Addendum #2

Invitation to Tender 2024-23

**General Contractor services for school addition at
ÉÉC Saint-Michel, 29 Meadowvale Rd, Scarborough**

**MECHANICAL & ELECTRICAL ADDENDUM #1
ÉÉC SAINT-MICHEL – CLASSROOM ADDITION
29 MEADOWVALE ROAD, SCARBOROUGH, ONTARIO. M1C 1R7
APRIL 24, 2024**

HOARDING FENCES TYPES:

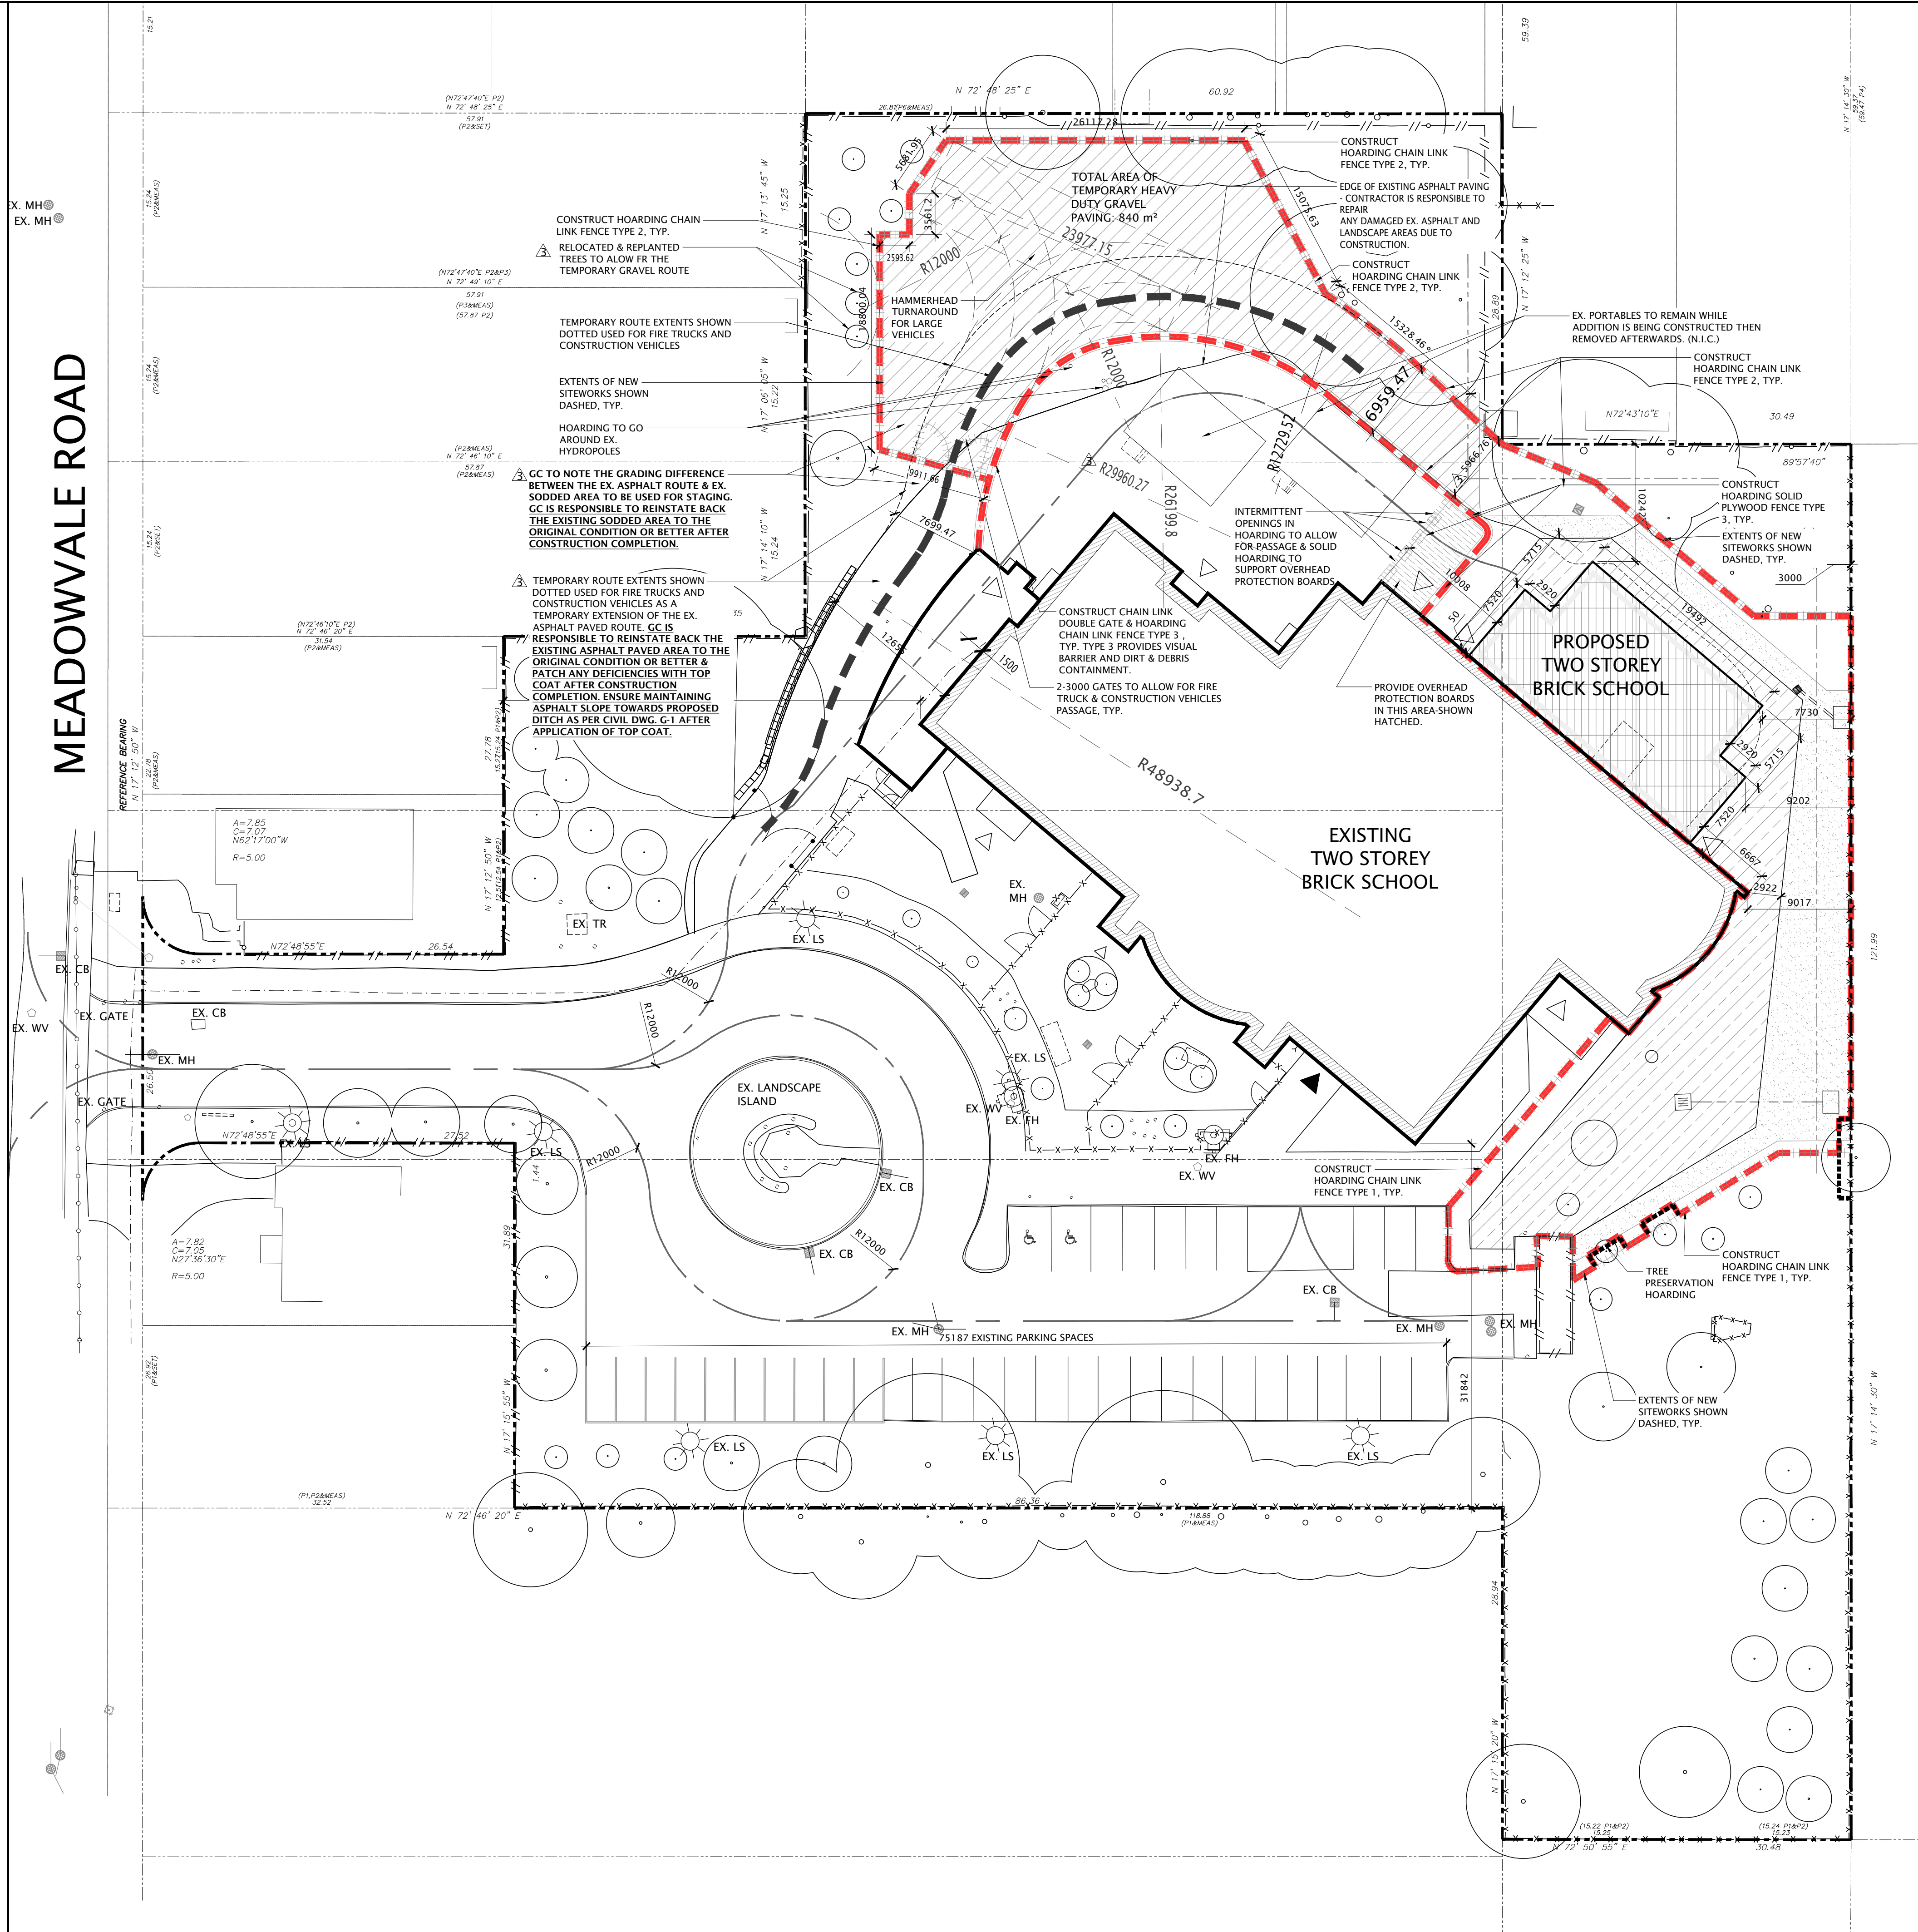
Question 2: Are details for the type 3 hoarding noted on A1-1 able to be provided for reference?

Answer 2: Details for hoarding type 3 have been incorporated into drawing A1-1 R3 attached and re-issued.

DRAWING TITLE:
INTERIOR ELEVATIONS

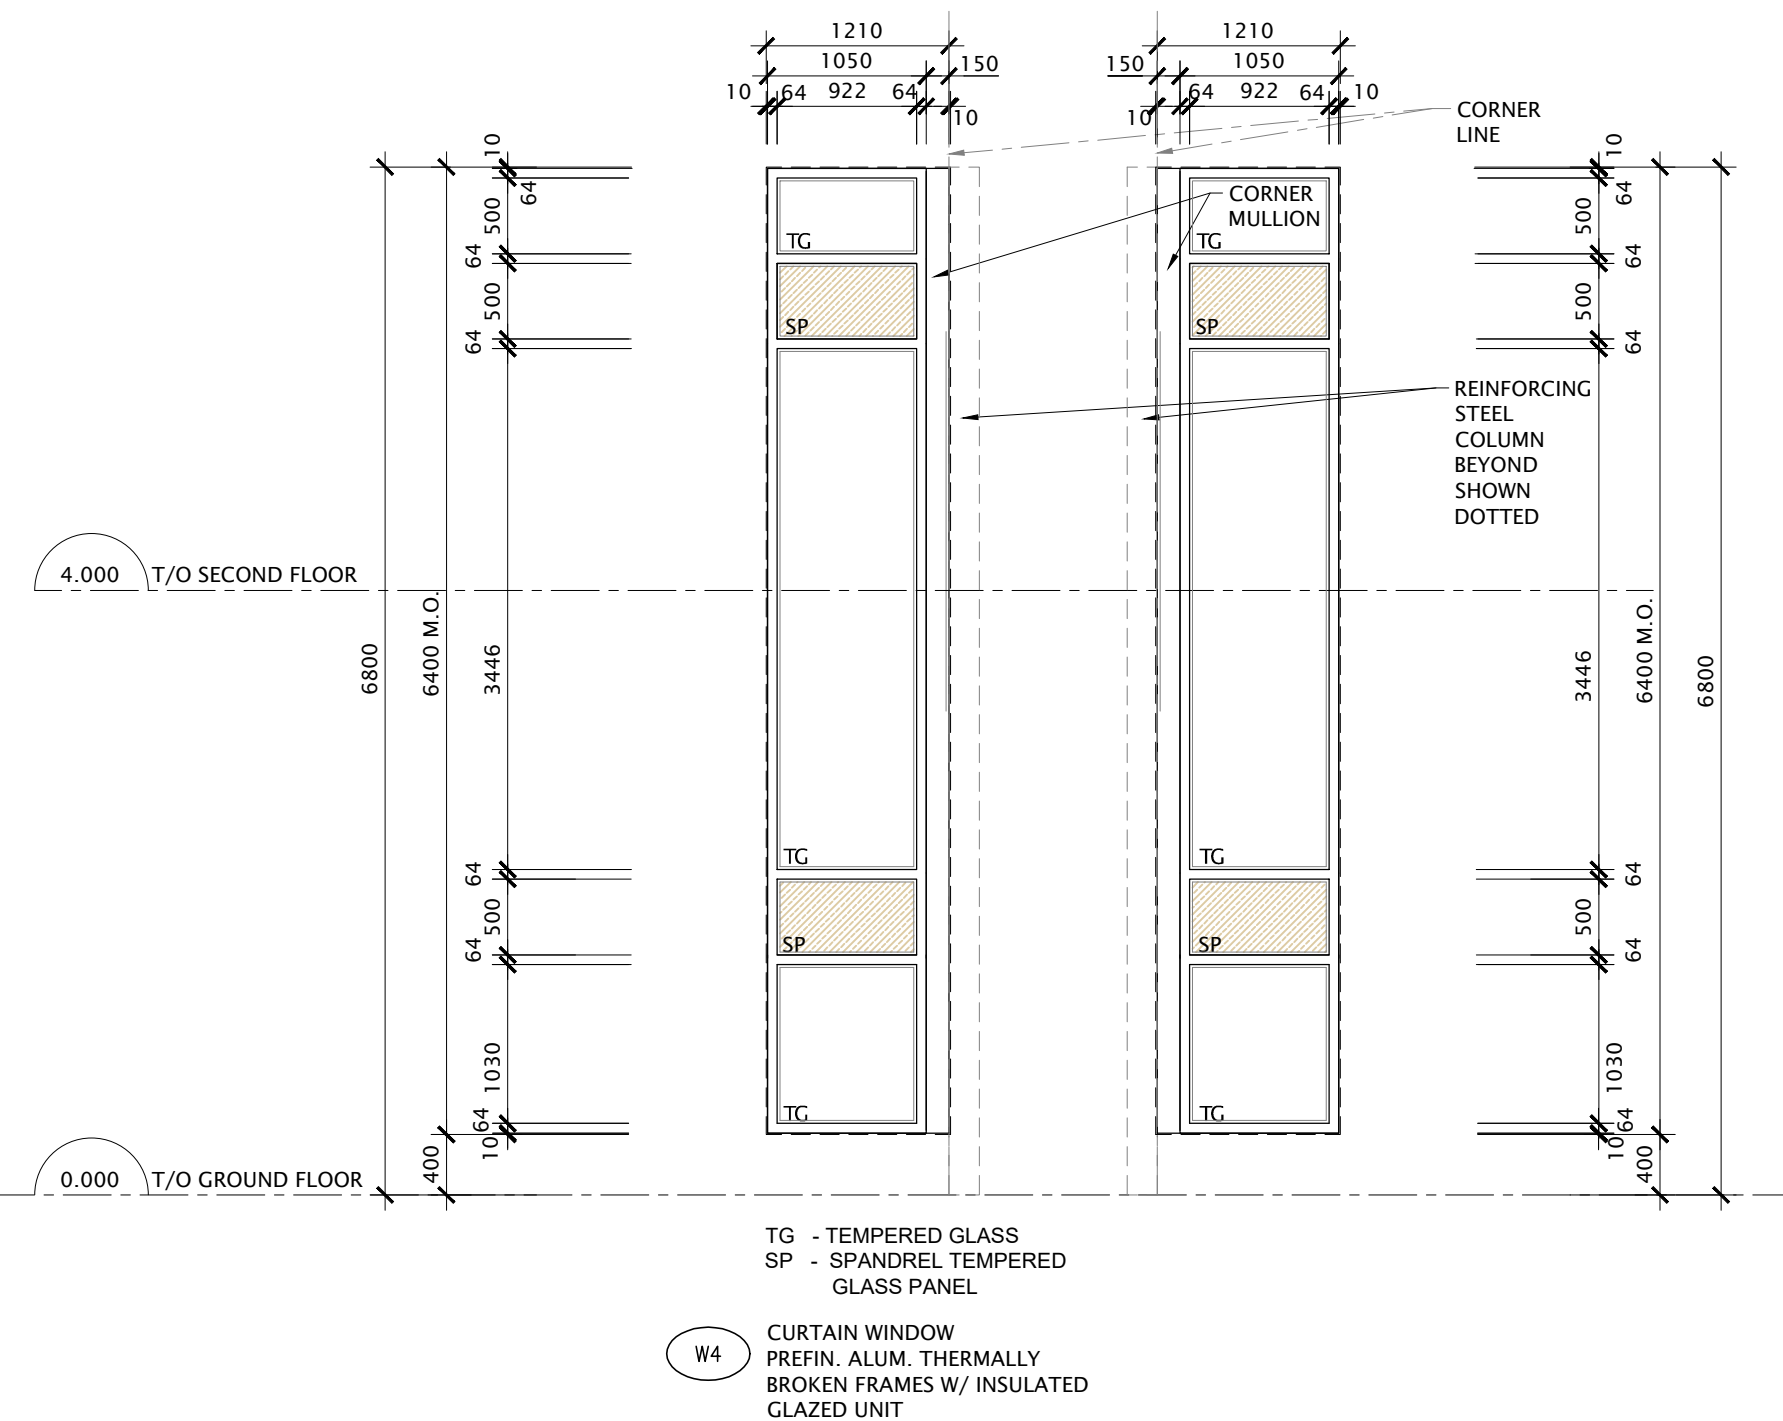
Question 4: As noted on A4.0 are we to supply and install the interactive smart board, if required please confirm manufacturer.

Answer 4: GC is to refer to electrical drawings (not re-issued) and provide only the data and receptacle outlets required for the smart interactive board. The CSC MonAvenir is responsible of providing the smart interactive boards and the GC will be responsible for their installation only.

3 HM DOORS AND SCREENS SCHEDULE
A8-0 SCALE: 1:50

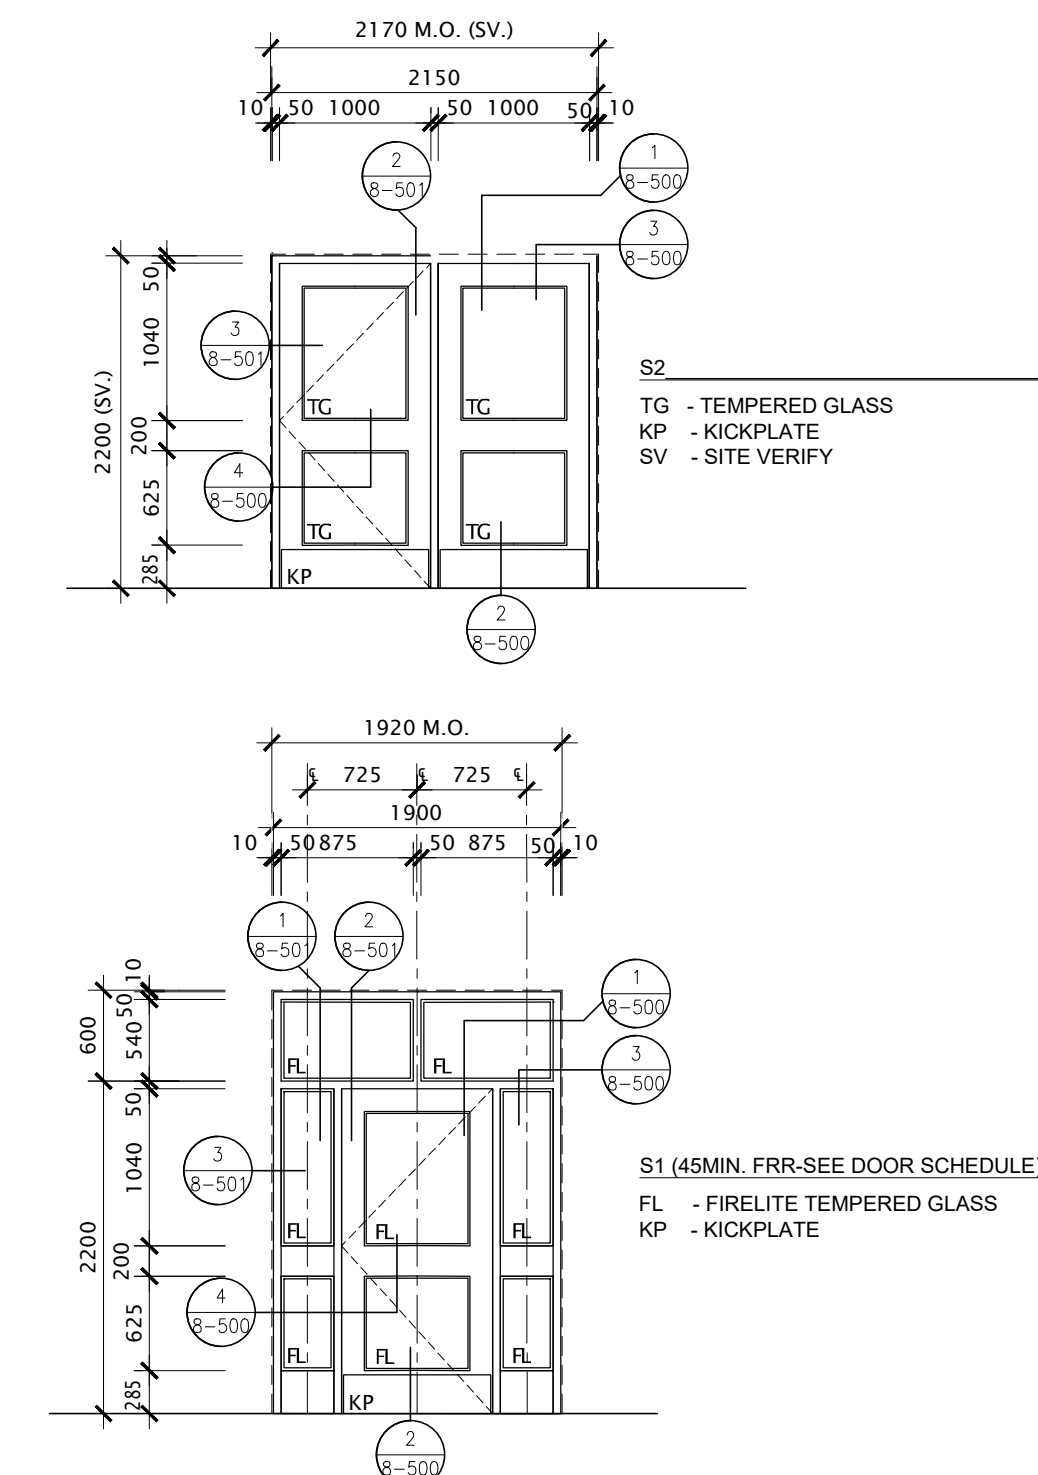
Question 10: Please confirm the material for the following Door Frames and windows.

- 1) Door 901a, Door 902a (Frame W1) elevation detail shows Hollow Metal Thermally Broken, door schedule references ALUM. Please clarify.
- 2) Window Type W3 and W5 elevations show Hollow Metal Thermally Broken but detail on drawings show ALUM, please clarify.

- 1) Refer to specs section 00861 (not re-issued): Doors 901a & 902a to be aluminum and their frames thermally broken aluminum.
- 2) Please see attached revised drawing A8-0 R4 that includes revisions for W3. W5 remains as is: 1HR FRR Painted HM.

Distribution Panel BB

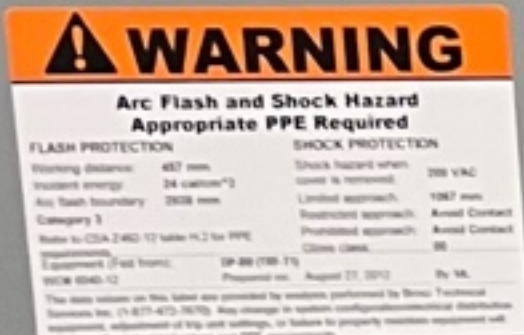
Question 7: Please send pictures of the distribution section & nameplates for existing distribution panels.

Answer 7: Please see attached the requested photos (2).
